SCHWEIZER SERVICE INFORMATION NOTICE

SUBJECT: INSTALLATION AND REPLACEMENT OF PROTECTIVE SLEEVE (SPEEDI-SLEEVE PN 084956) ON TAIL ROTOR TRANSMISSION OUTPUT GEARSHAFT.

MODELS AFFECTED: All 269 Series Helicopters equipped with a 369A5400 Series Tail Rotor Transmission.

Figure 1. Speedi-Sleeve (PN 084956) Installation/Replacement

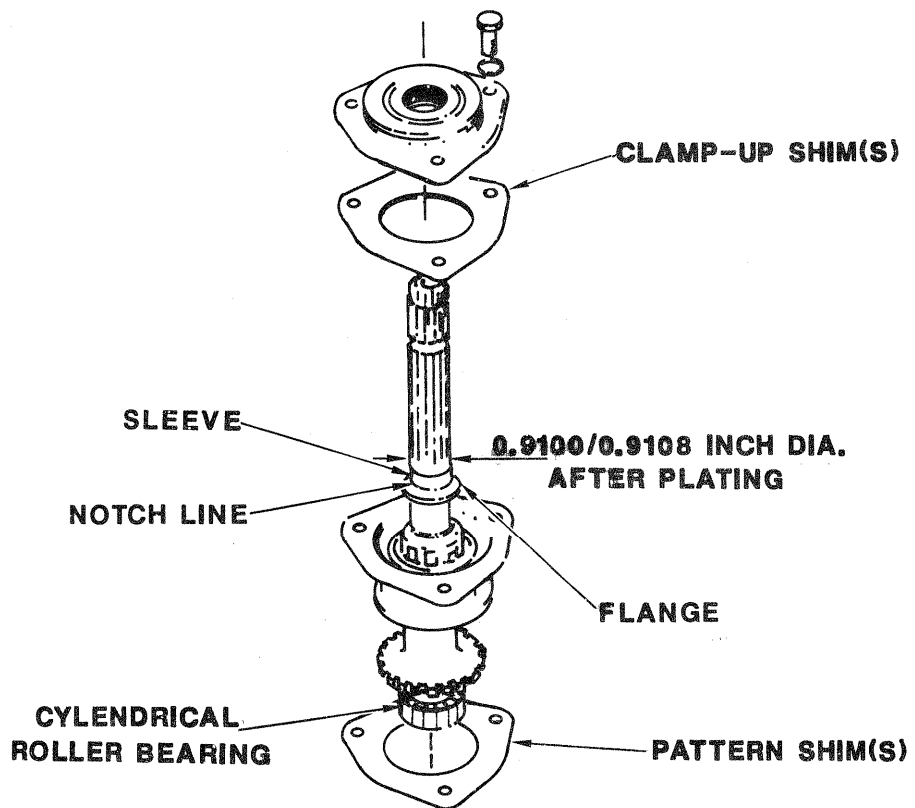
- d. Using heat gun or blow dryer, heat output housing bore to $275 \pm 25^{\circ}\text{F}$ ($135 \pm 12^{\circ}\text{C}$); remove gearshaft and pattern shim. Retain and identify pattern shim(s).
- e. Replace an installed sleeve, if damaged or grooved, as follows and as shown in Figure 1.

- (1) Use file or other suitable instrument to cut through edge of sleeve; carefully pry cut edge away from shaft.
- (2) Grasp raised edge with pliers and peel damaged sleeve off shaft.
- (3) Remove any Devcon residue from shaft using dry cleaning solvent (PD-680); dry shaft with clean, lint free cloth.

- f. Install Speedi-Sleeve as follows: (See Figure 1.)

- (1) Wipe away dust particles and foreign material from gearshaft using a clean, lint free cloth, dampened by solvent.
 - (2) Inspect shaft for wear. If shaft has been grooved from rubbing against lip of output gearshaft cover seal, and depth of groove exceeds 0.005 inch, shaft must be replaced. (Refer to HMI Appendix C, Part III.)

- (3) If shaft has been grooved by seal lip and groove does not exceed 0.005 inch depth, fill groove with Devcon A.
 - (4) Apply light coat of plastic steel (Devcon A) to shaft area to be covered by sleeve.

- (5) Set gearshaft on end, roller bearings down, on hard clean, level surface. While Devcon A is wet, put sleeve on shaft, flange down, and press or tap in place using installation tool bottomed on flange of sleeve. The unflanged end of sleeve must be even with outboard end of 0.9100 - 0.9108-inch diameter seal journal. Tap end of tool with hammer or mallet as necessary to correctly position sleeve on shaft. Wipe any excess Devcon A from shaft using a clean, lint free cloth.

- (6) Clip flange of sleeve to notch line and peel from shaft.
- g. Reassemble tail rotor transmission as follows:
- (1) Apply heavy coating of petroleum jelly to roller bearings on end of gearshaft.
